UNITED STATES PATENT AND TRADEMARK OFFICE

APPLICATION NO.	FILING DATE	FIRST NAMED INVENTOR	ATTORNEY DOCKET NO.	CONFIRMATION NO.
09/960,086	09/20/2001	Rajiv Doshi	19441-0034	5046
7590	08/10/2004		EXAMINER	
Daniel J Warren Sutherland Asbill & Brennan LLP 999 Peachtree Street N E Atlanta, GA 30309-3996			CHANEY, CAROL DIANE	
			ART UNIT	PAPER NUMBER
			1745

Office Action Summary

Claim Rejections - 35 USC § 102

Fig.1

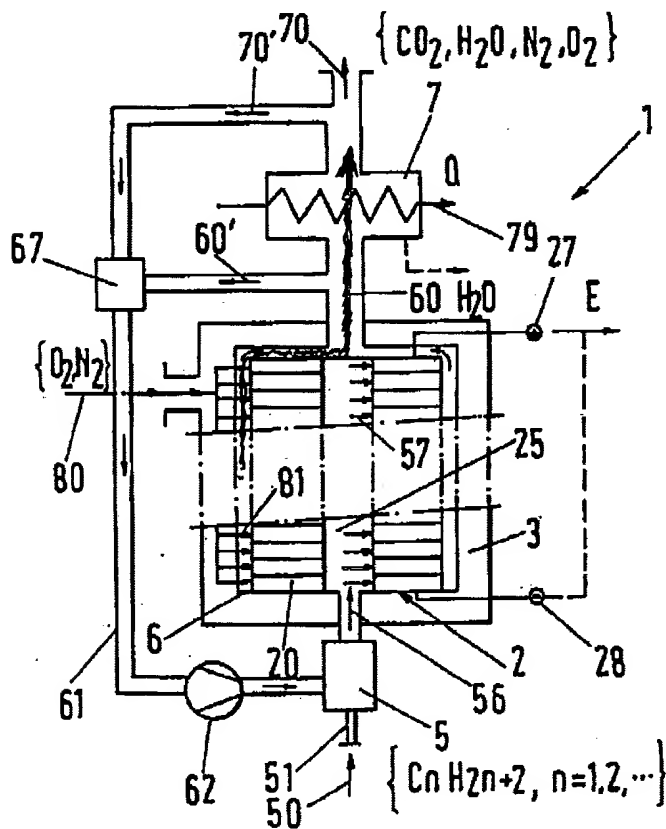
Applicants assert Schuler shows no fluid delivered from the "second interior cavity 6". However, as shown in Fig. 1 of the Schuler patent, fluid is clearly delivered from second interior cavity. The cavity could not accept an input of fluid without a fluid flow from the cavity.
